We appreciate the opportunity to comment on NorthWestern Energy's Draft 2019 Electricity Supply Resource Procurement Plan.

NORTHWESTERN ENERGY 2019 ELECTRICITY SUPPLY RESOURCE PROCUREMENT PLAN

GB Energy Park, LLC
Comments on NorthWestern Energy's Draft 2019 Plan
5/4/19
Page i of 34

Figure 2. PSH operational range versus gas.

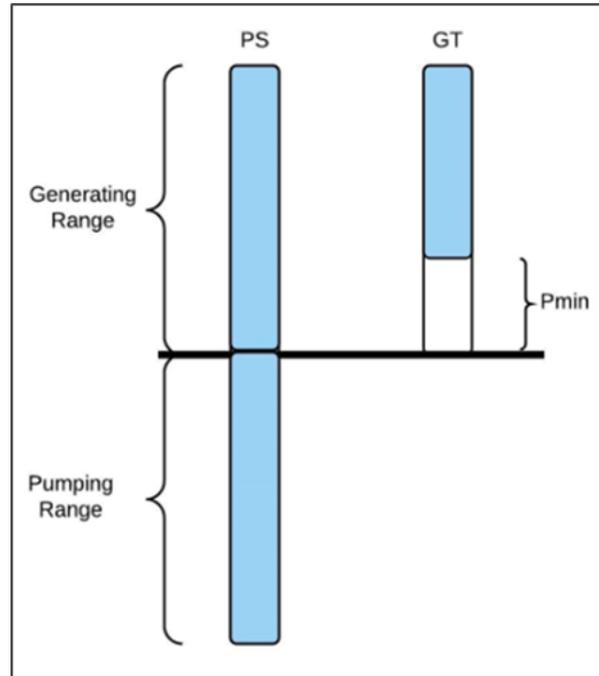
Simply put, an energy storage facility is able to be operated for flexible capacity at 200% of its nameplate, while a gas unit can only offer some fraction of its overall nameplate for the same service (see Figure 2 below).

Figure 4. PSH Load Regulation – Morning Load Ramp

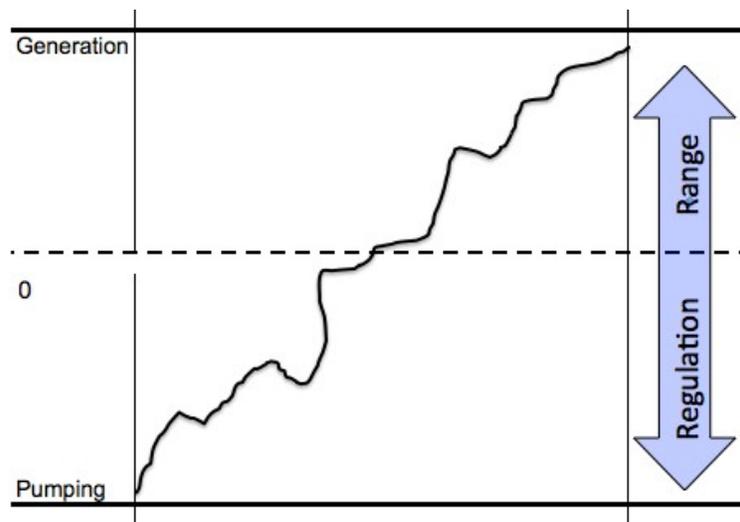
- ✦ Alternatively, this 150 MW load ramp could also be met 75 MW of PSH ramping from 75 MW pumping to 75 MW generating. The PSH would produce no net out-of-market energy over this hour.

Figure 5. PSH Load Regulation – Typical Nighttime Hour

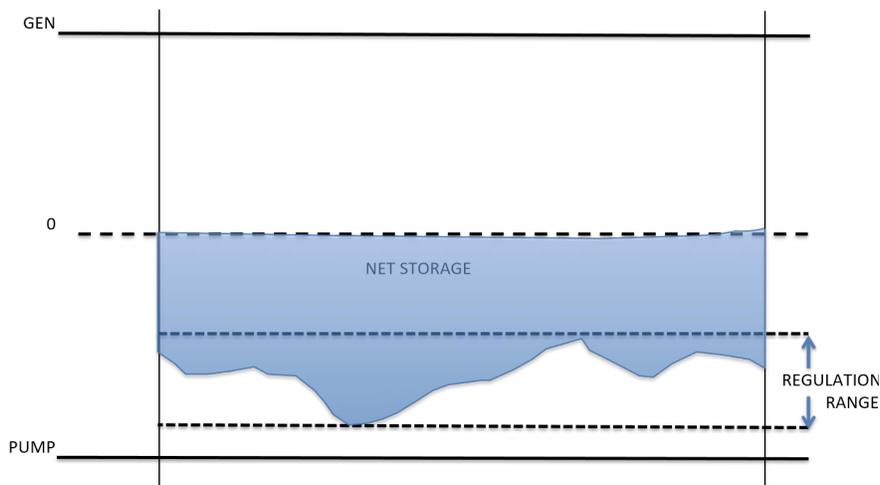
producing out-of-market energy, the PSH would be expected to store 50 MWh of energy that would be available at attractive prices during nighttime hours.³²

Figure 6. PSH Wind Regulation –High Wind Hour

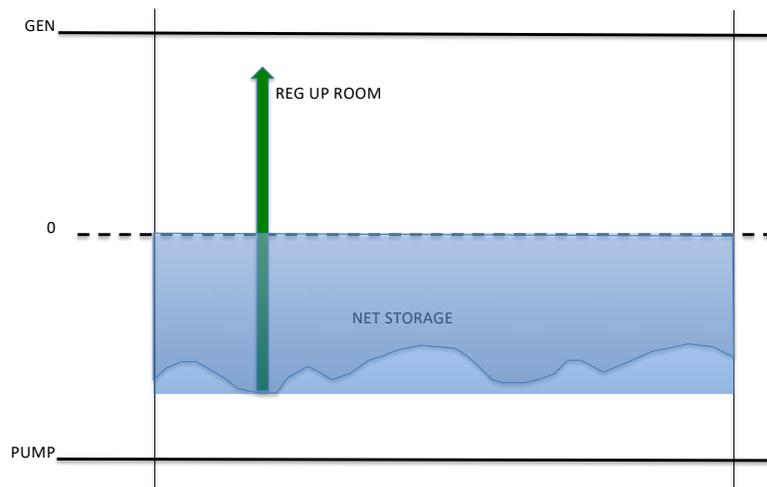
- ✦ This need could be met by 150 MW of RICE on-line and ready to ramp up if the wind does fall off.
- ✦ The same need could be met by 75 MW of PSH set to 75 MW pumping and ready to ramp up to 75 MW generation if the wind does fall off. If the wind does not fall off, the PSH would store 75 MWh of wind energy that would likely be in excess of NWE's needs.

Figure 1. “Short Term Base” resource portfolio

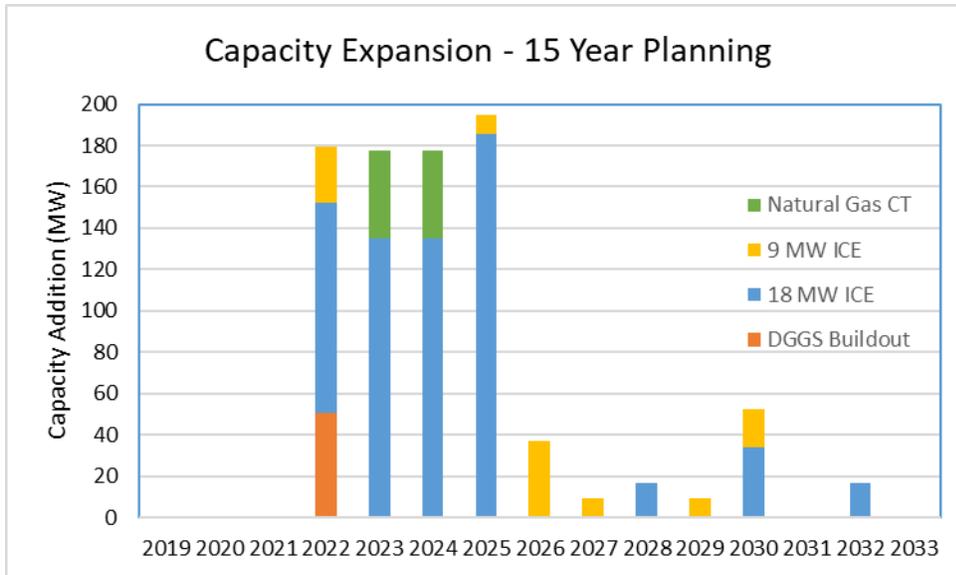
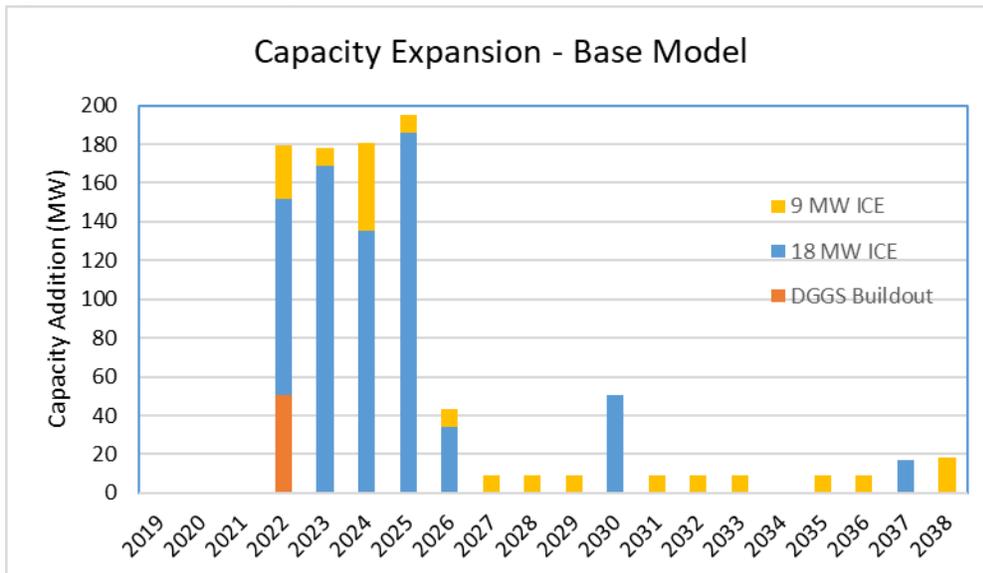
the 20 year analysis period. The “Short Term Base” portfolio is shown in Figure 1 and the “Base” portfolio is shown in Figure 2, below.

The intent of the Commission’s comments and recommendations regarding a 15-year planning horizon and cost recovery is to protect customers against NorthWestern’s acquisition of particular assets that may become stranded at some future date. In modeling the 15-year planning horizon with cost recovery, NWE is following the letter of the Commission’s recommendation. Given that the asset mix does not change from the “Base” portfolio to the “Short Term Base” portfolio, however, and the Company provides no context or analysis justifying the results with respect to the PSC concerns, the Company is not following with the spirit of the Commission’s recommendation.

Response: This issue is addressed in Chapter 11.
